Preliminary Consultation
MONTGOMERY COUNTY HISTORIC PRESERVATION COMMISSION
STAFF REPORT

Address:	4711 Waverly Avenue, Garrett Park	Meeting Date:	8/17/2022
Resource:	Outstanding Resource (Garrett Park Historic District)	Report Date:	8/10/2022
Applicant:	M. Russell-Einhorne	Public Notice:	8/3/2022 Dan
PROPOSAL:	Building Addition	Staff:	Bruechert

○ Proposed Right Elevation
 1/4" = 1'-0"

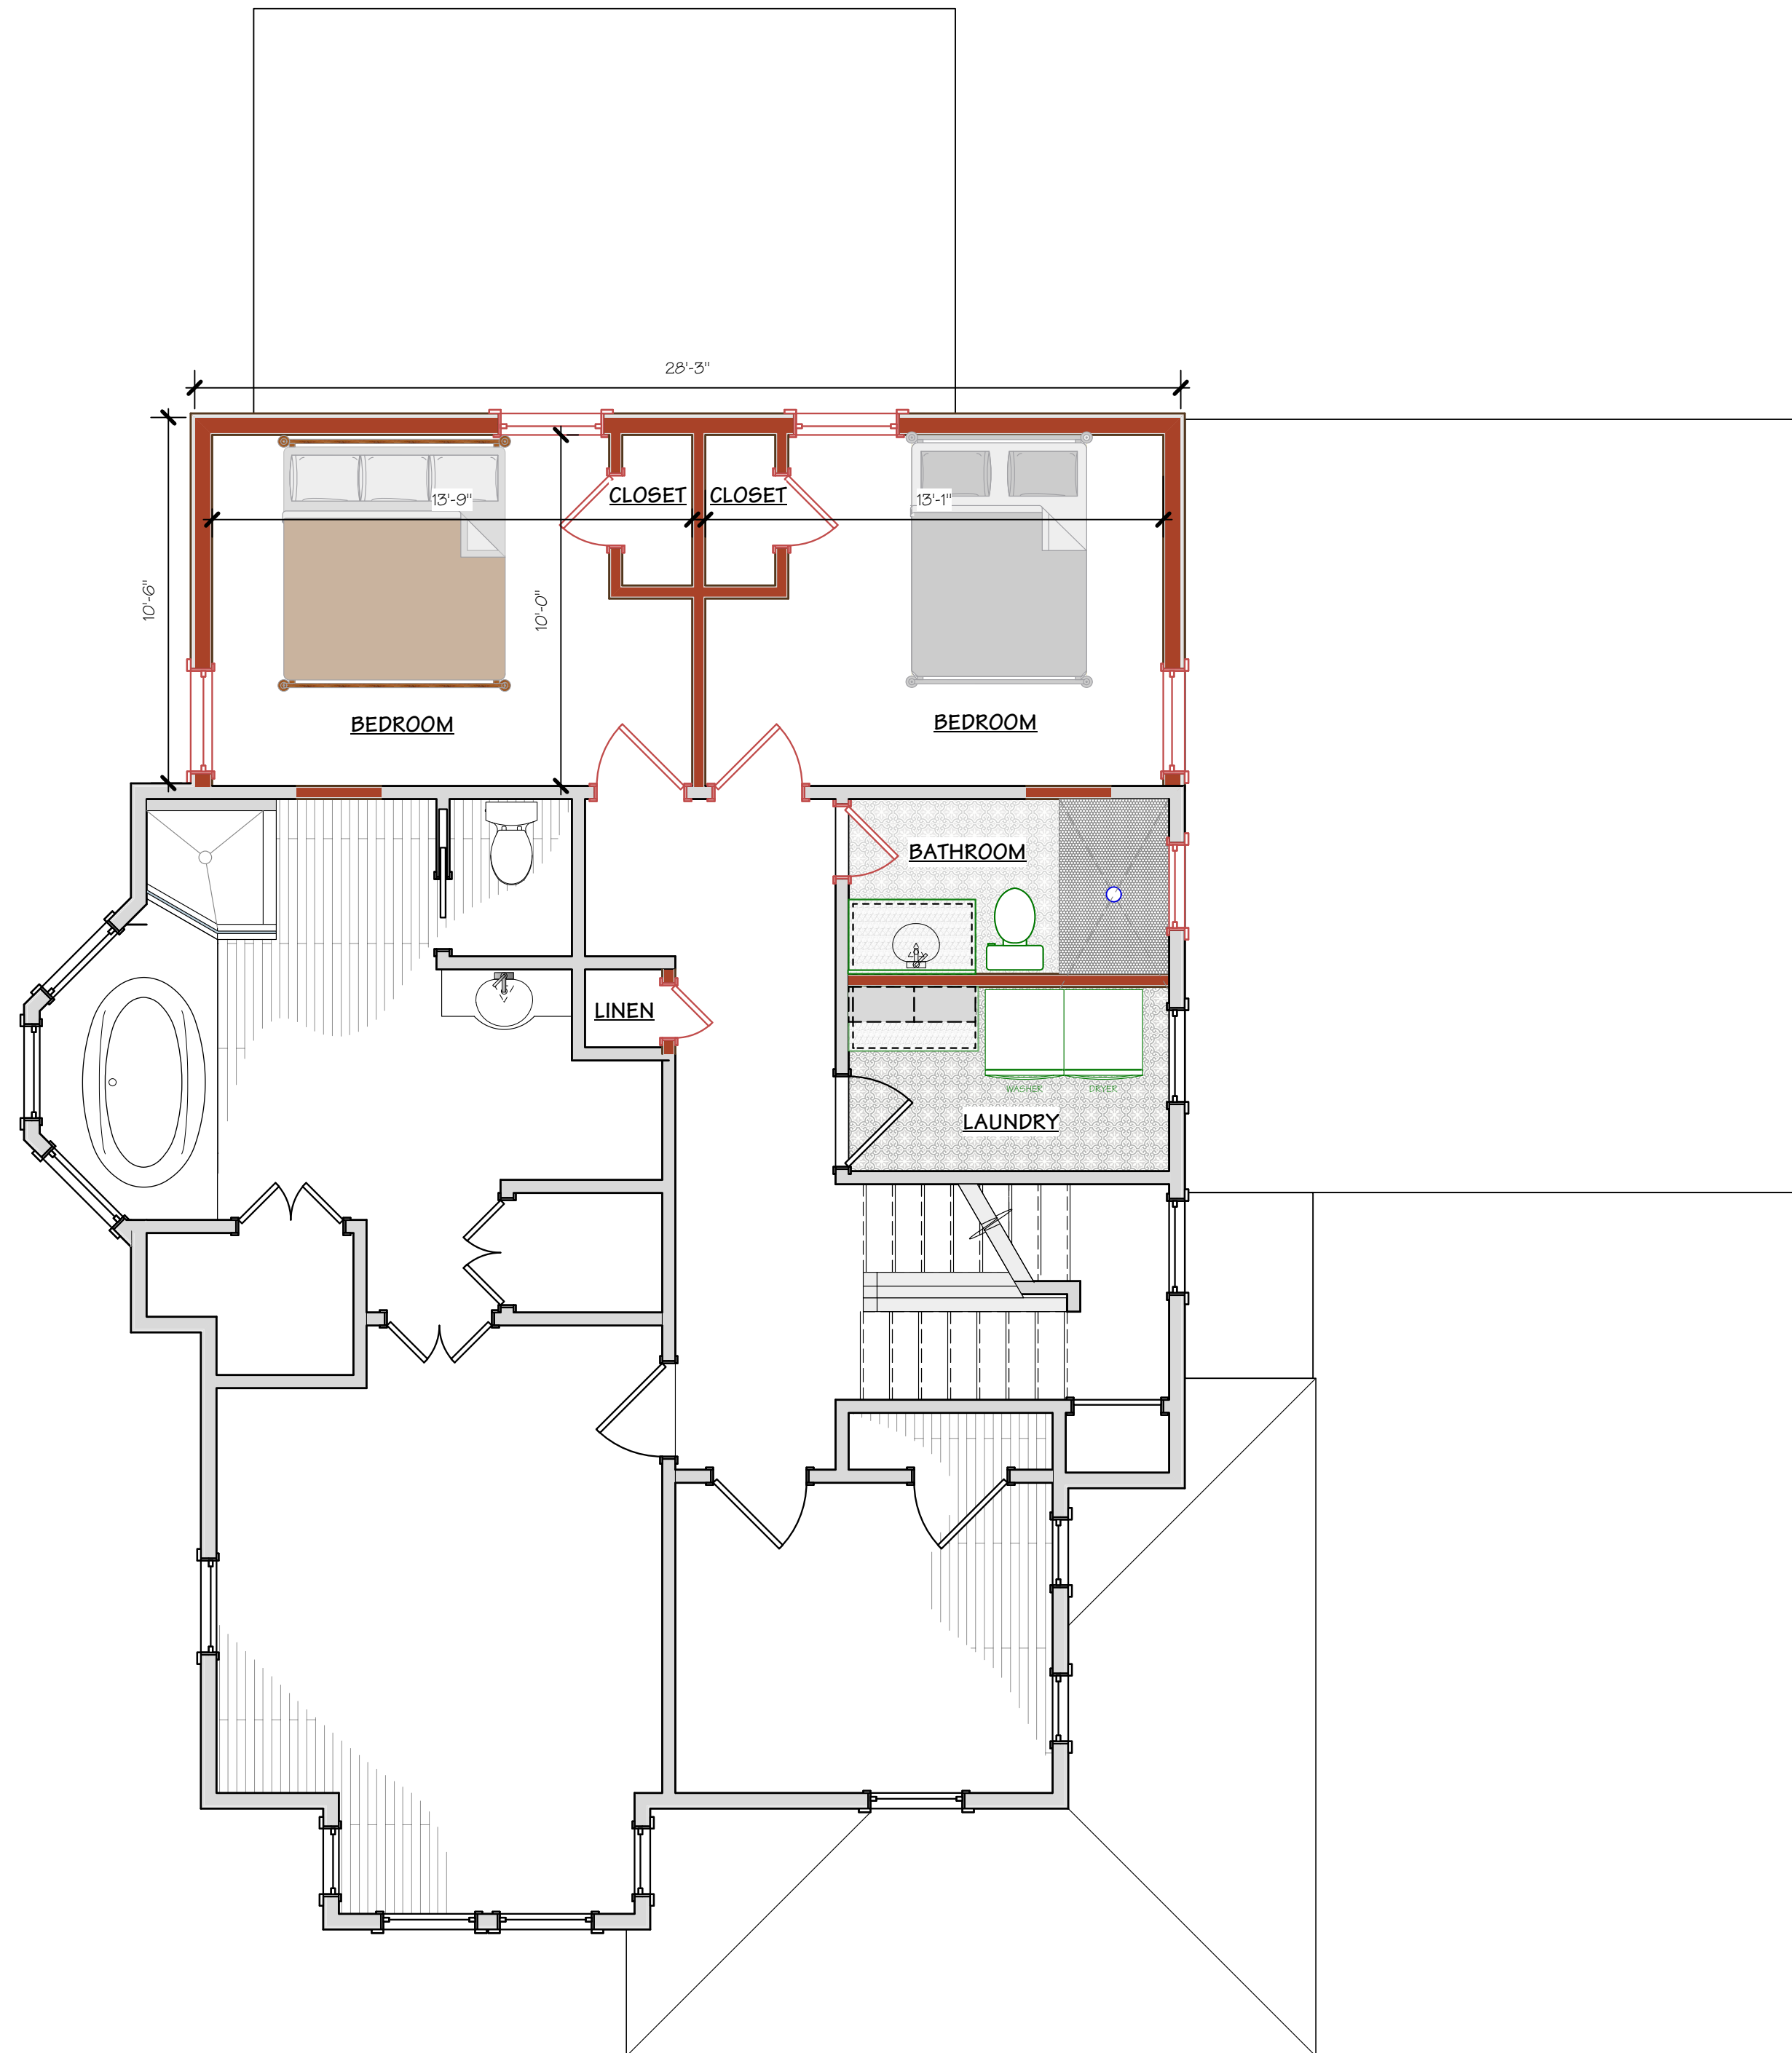
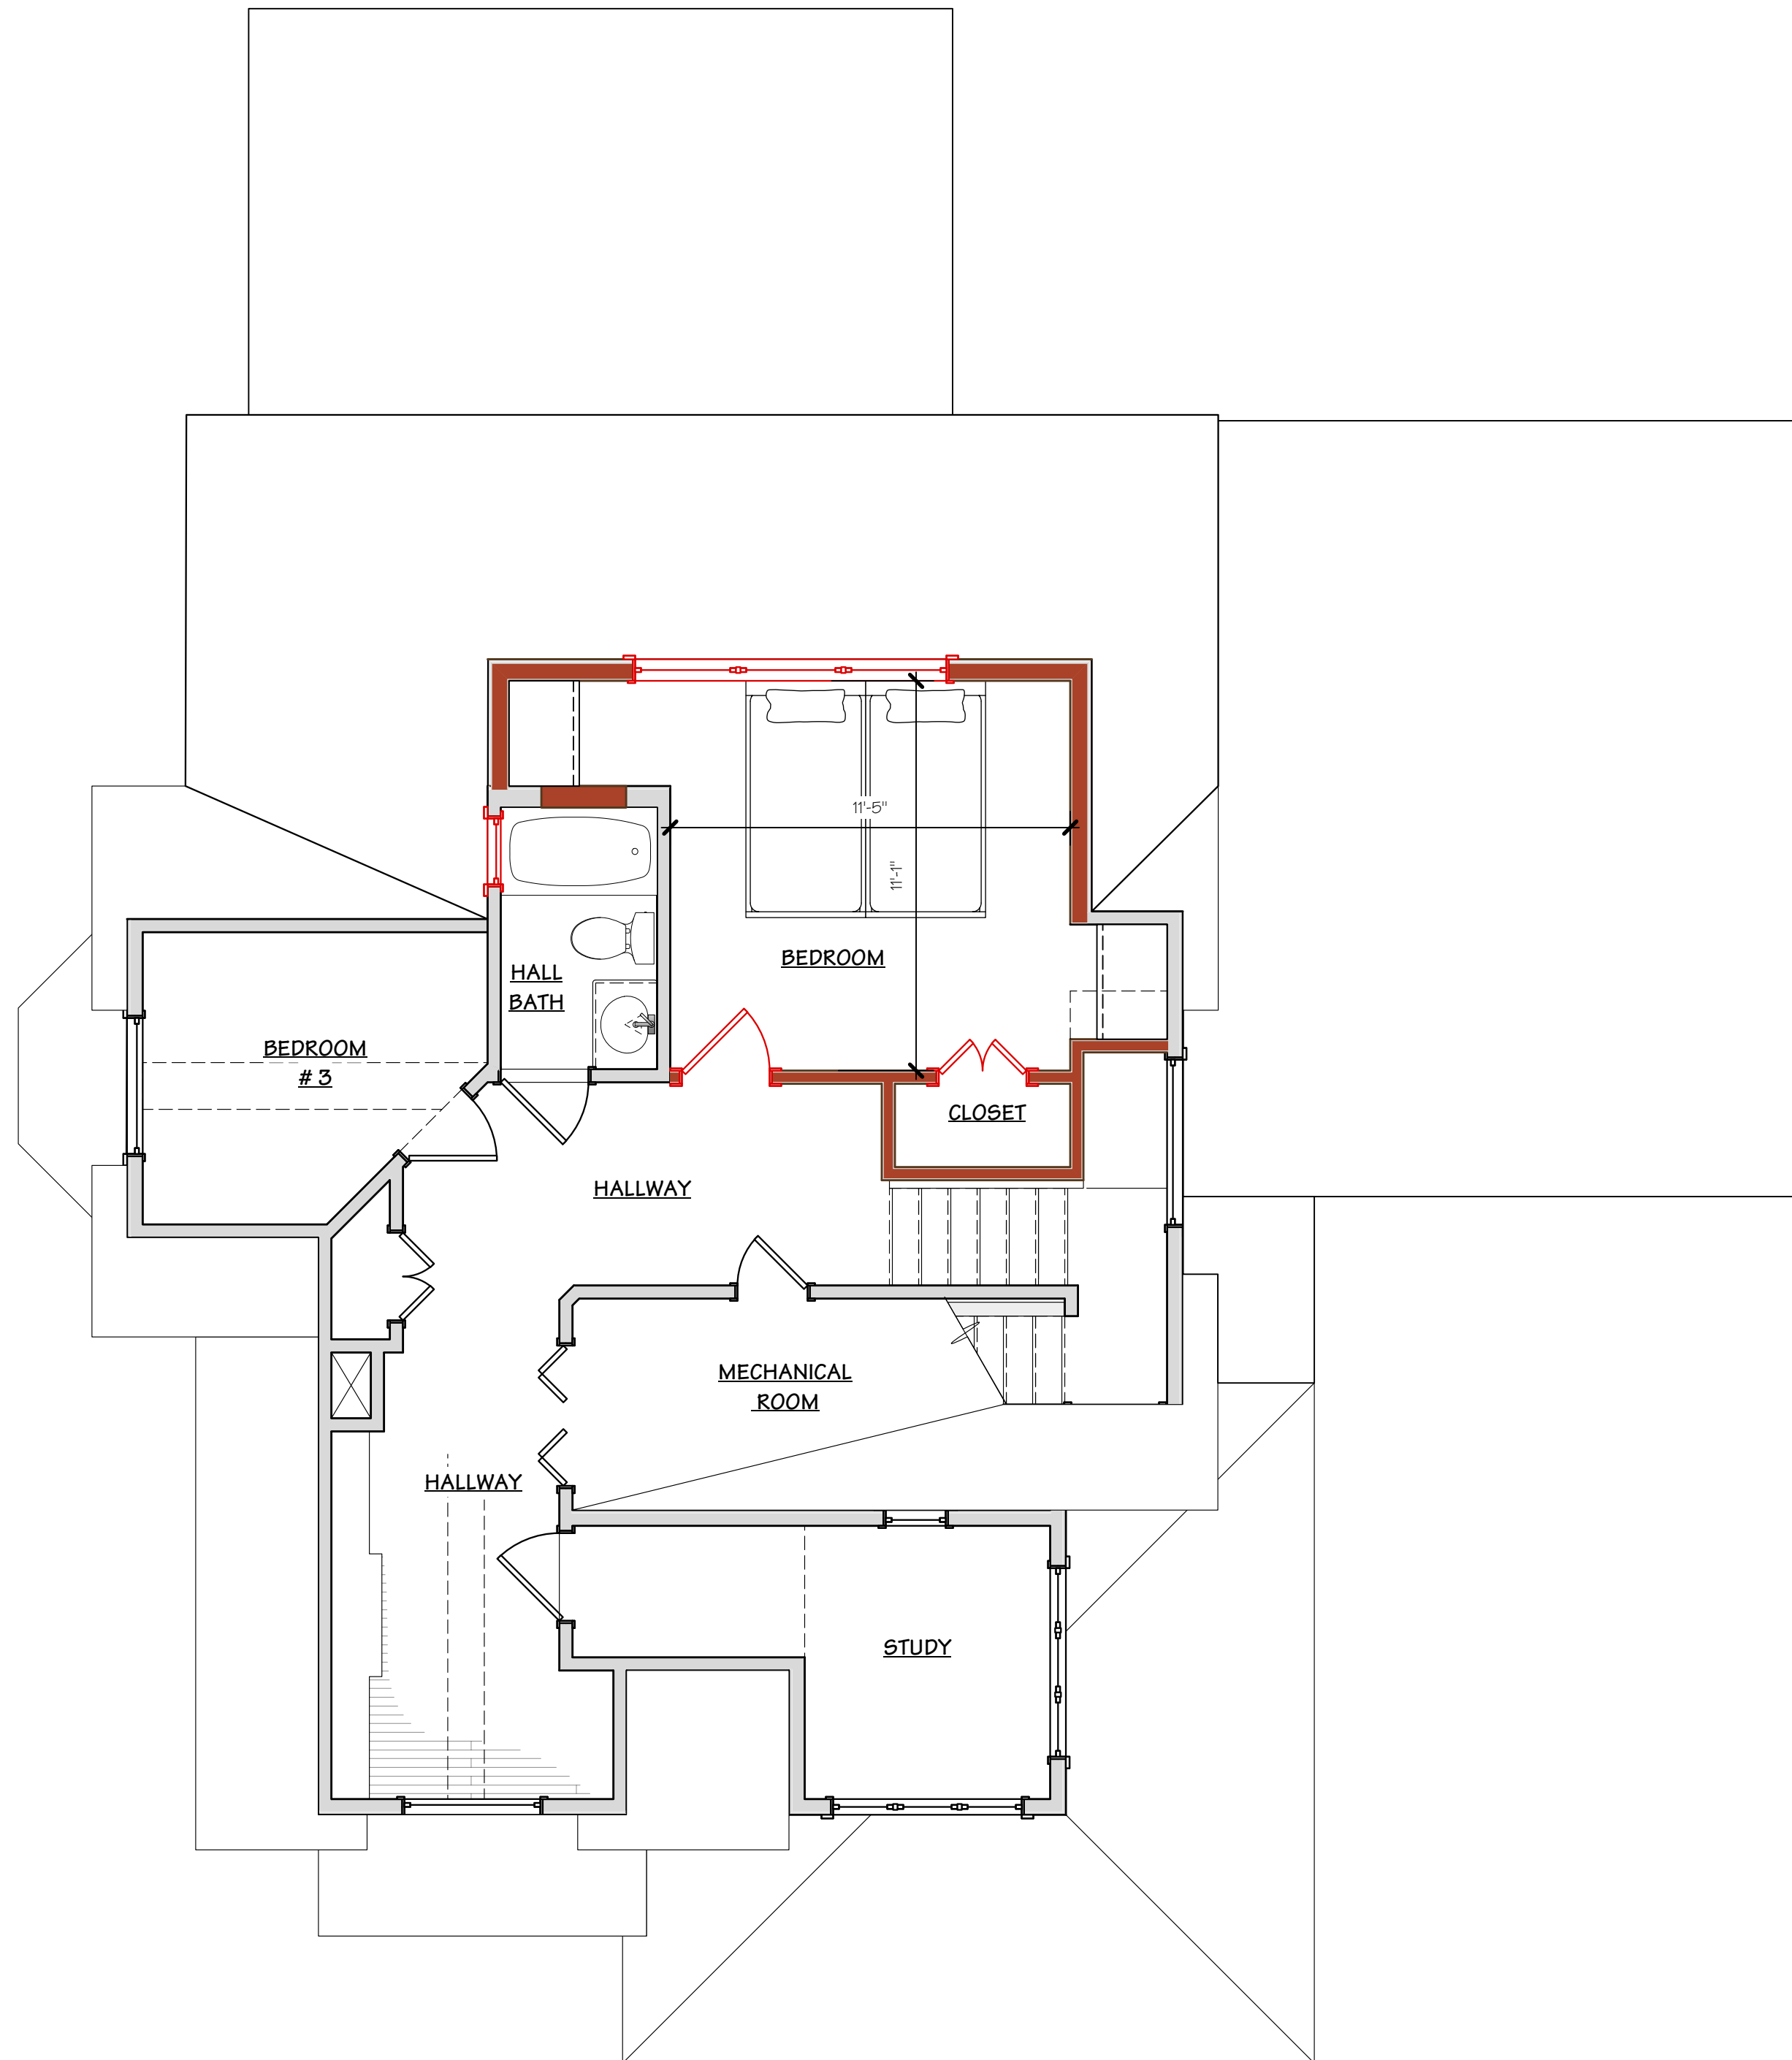
Staff has additional concerns about the proposed window patterns shown on the elevation drawings. Because these drawings are still in the developmental stages, they may only be illustrative, but addressing this issue at the preliminary stages can better lead to an approvable HAWP. Staff finds the single lite windows with transoms above in the front elevation of the side addition are incompatible with the

character of the house, as well as the large window on the east elevation. The configuration of these windows needs to be revised. The other windows shown on the drawings are a variety of casement and one-over-one sash windows. Staff finds that two-over-two windows would better match the character of the house, but acknowledges that the majority of the new windows are entitled to a slightly more lenient review because they are on the rear elevation and will not be visible from the public right-of-way. Staff requests the HPC's guidance about the proposed window configuration in the new construction.

At the intersection of the historic building and the second-floor addition, the drawing shows a vertical line. Unfortunately, the drawing lacks specificity in detailing the exterior walls treatment and how the new will be differentiated from the historic. The second-floor plan drawing shows the addition is co-planer to the historic exterior wall. The general requirement is that additions are inset from the historic wall planes to preserve the historic house outline and to differentiate the old from the new. Staff finds the addition's design would be more successful if the northeast (right rear) corner was retained and the addition was inset by at least 1' (one foot) from the corner. Staff asks the HPC for feedback on the appropriateness of installing a co-planer addition that preserves the corner boards or whether the standard practice of inseting the addition's wall planes should be applied in this case.
